| PROPOSED CARPORT / SHED FOR DAWN STEPHENS | | |

| 17 PATTERSON ST DENMARK W.A. | PAULS WELDING SERVICE. | CLIENT: D. STEPHENS | DATE: AUG 2014 | DRAWN: PAUL. |

SCHEDULE OF SUBMISSIONS: PROPOSED SINGLE HOUSE ADDITIONS AND OUTBUILDING – NO. 17 (LOT 865) PATERSON STREET DENMARK

| | 0428384913. | PROJECT: PROPOSED CARPORT | SCALE: AS SHOWN | DWG NO DS 02 |

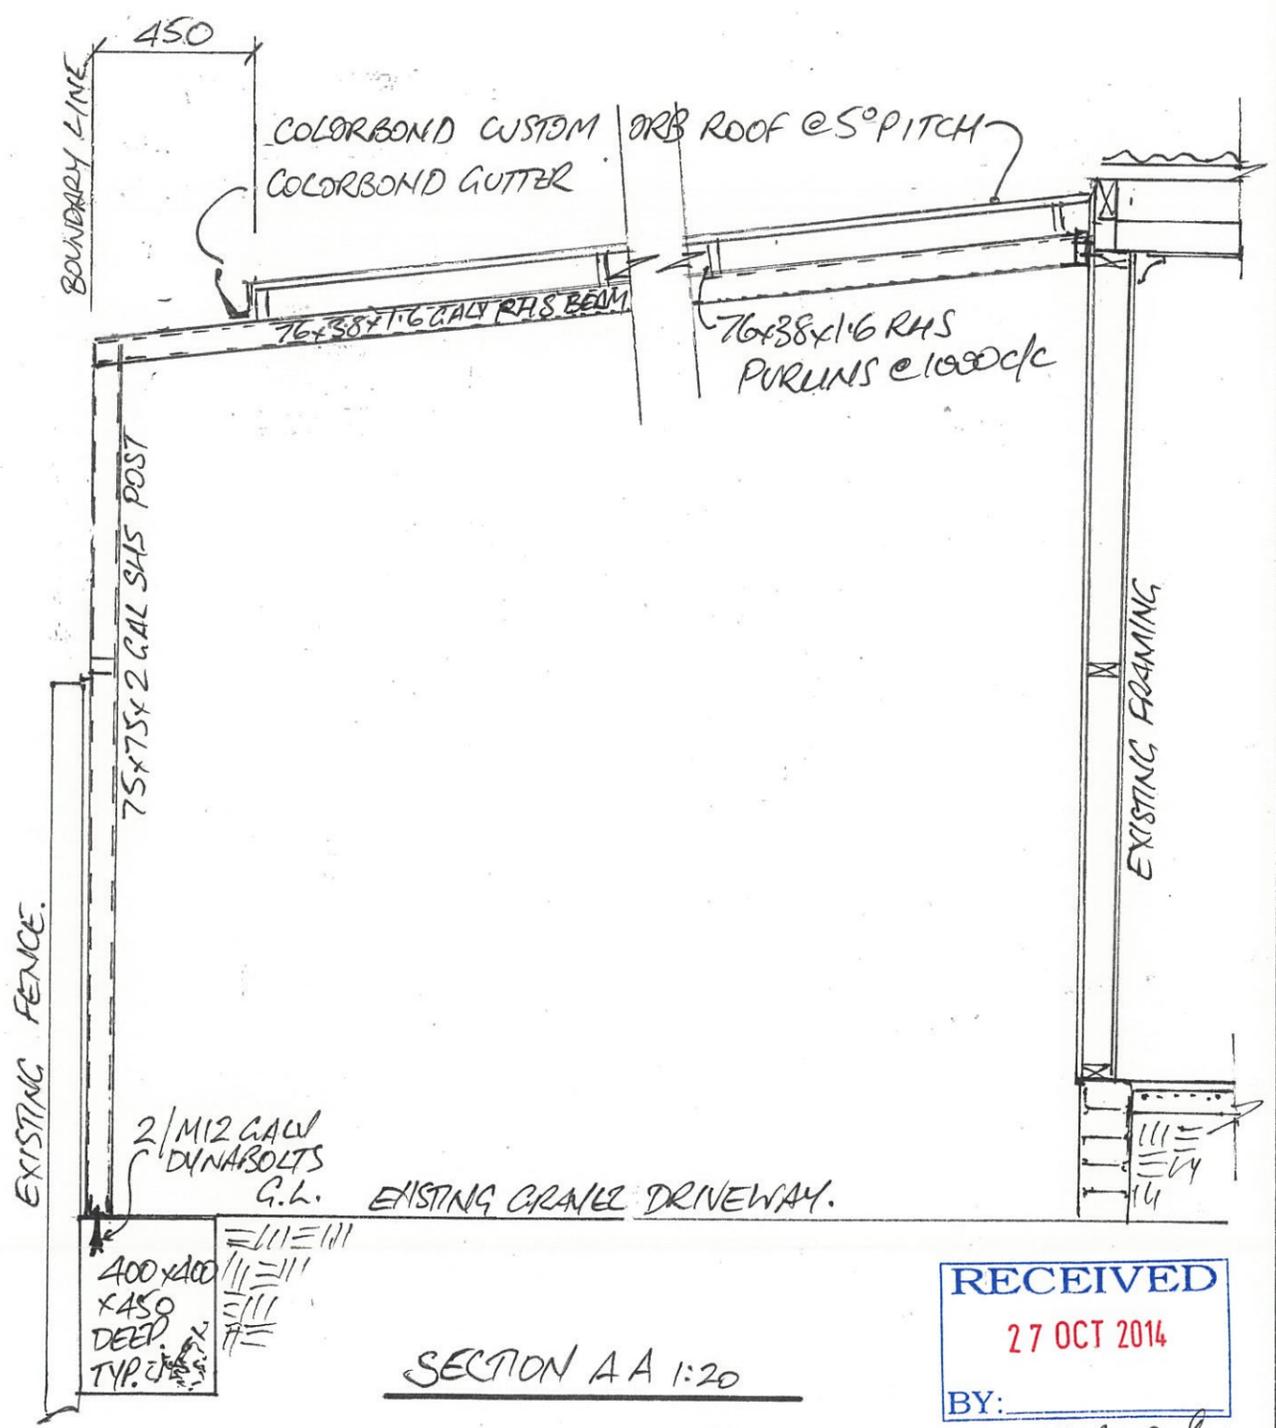
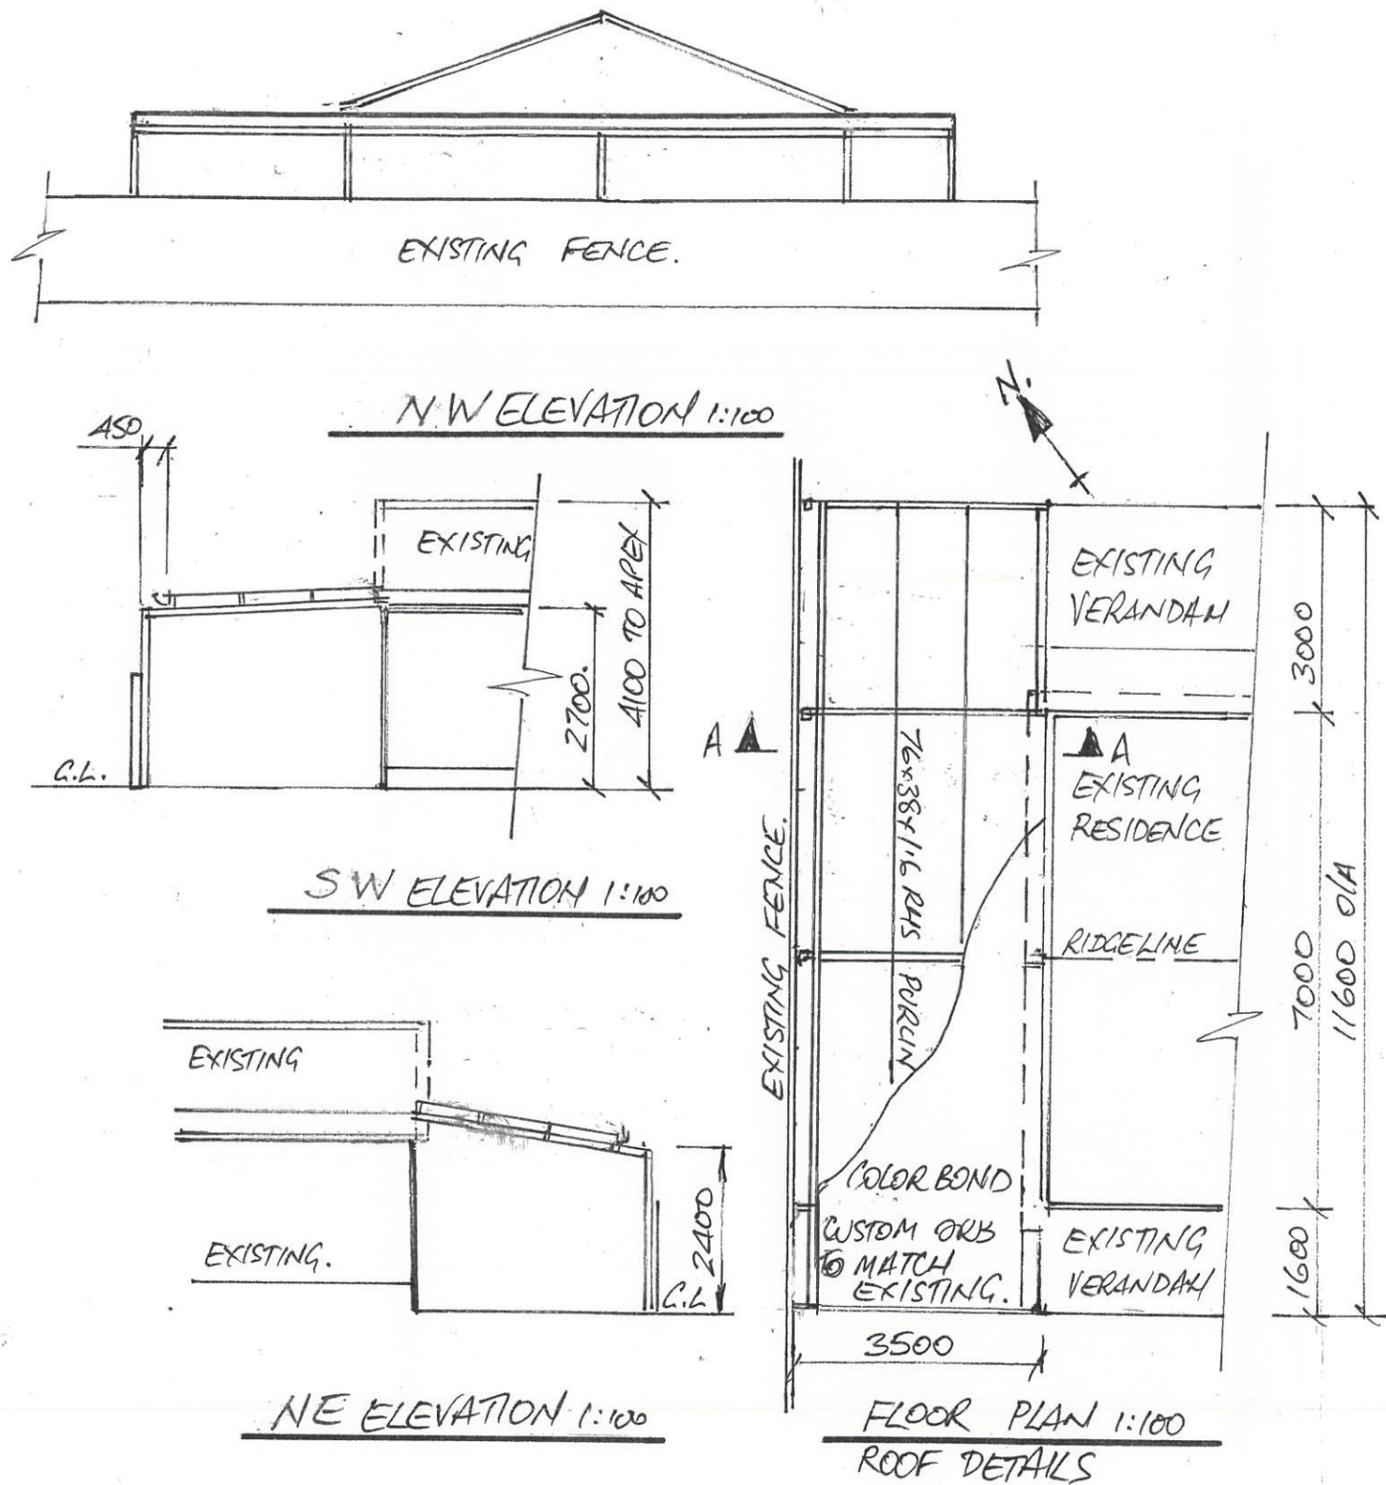
- c. *Most importantly to me*, due to a slope, the existing rear patio deck floor is more than 400cm higher than my ground level. *Could not this floor deck could be extended at any time, perhaps by future owners, along the extension roof right to my boundary?* This would mean that people sitting or standing at leisure on the patio deck very close to my boundary would be able to look from a high vantage into my carport, my home, rear yard and even front yard at their leisure potentially embarrassing me. This would be a significant and worrying intrusion on my privacy and psychological well being while I am at home.

- d. Due to the reasons stated above the value of my property would presumably be reduced.
- e. Note that the proposed additional 3m patio extension does not give covered access to the rear of the house due to the 4m difference in floor level and the existing barrier on the patio which bars access from the proposed extension.

1. The average Australian "large family car" length is 4.8m (Wikipedia) and thus 2 large cars could park end to end in a carport of length 10.3m allowing for 300mm between cars and 200mm overhang either end. Therefore the minimum carport length could be 10.3m rather than the 11.6m proposed.
2. This 1.3m reduction in length would cause no problems regarding the gutter or downpipes as they not on the ends but on the roof adjacent to the common

In summary, if the Council does decide to override the regulations to allow a boundary wall greater than 9m, I plead for the carport to have the minimum length needed for 2 cars to park end to end. This means the wall length be reduced to 10.3m rather than the 11.6m proposed. This would significantly lessen the detrimental impact to my wellbeing and the amenity of my home while still allowing my neighbour to have full amenity for the carport. Furthermore, the length reduction would create no building problems and would presumably save money.

1. The 1.5m side boundary setback requirement for a boundary wall greater than 9m, under Residential Design Codes (R-Codes) Deemed-to-Comply criteria and Town Planning Scheme (Policy 13.4), is not met;
2. The extension would spoil the perceived high amenity of his bordering outdoor dining space thus causing him significant concern;
3. If the patio veranda floor deck, 400cm higher than ground level, were to be built up to the boundary, which could happen at any time without Shire approval, would further dominate and intrude upon his privacy, and thus decrease both his well being and the value of his property.

REVISED OCT 24: SKILLION ROOF. &
 : SIDE WALL SHEETS REMOVED
 REVISED SEPT 3: ROOF SHEETING - 450mm &

3. [REDACTED] states he has no objection to the length being 9m long and 3.5 metres wide: I will state here that I have submitted to council a change of my original plans, at my own expense, so [REDACTED] would feel more comfortable with the carport. The original plan was to follow the roof line of my roof. The amended plan, you can see before you, is lowered considerably to be a skillion roof, approximately the same height as [REDACTED] own carport, which is alongside my proposed carport. (See photo A)

- a) [REDACTED] states that the boundary wall totals 11.6m and contravenes the relevant planning regulations that a wall on the common boundary be no greater than 9m long: I can only surmise that [REDACTED] has misunderstood my plans as there is no 'wall' on the common boundary? Also, I have liaised extensively with the council and have not been advised at any point that my proposed building contravenes council planning regulations.
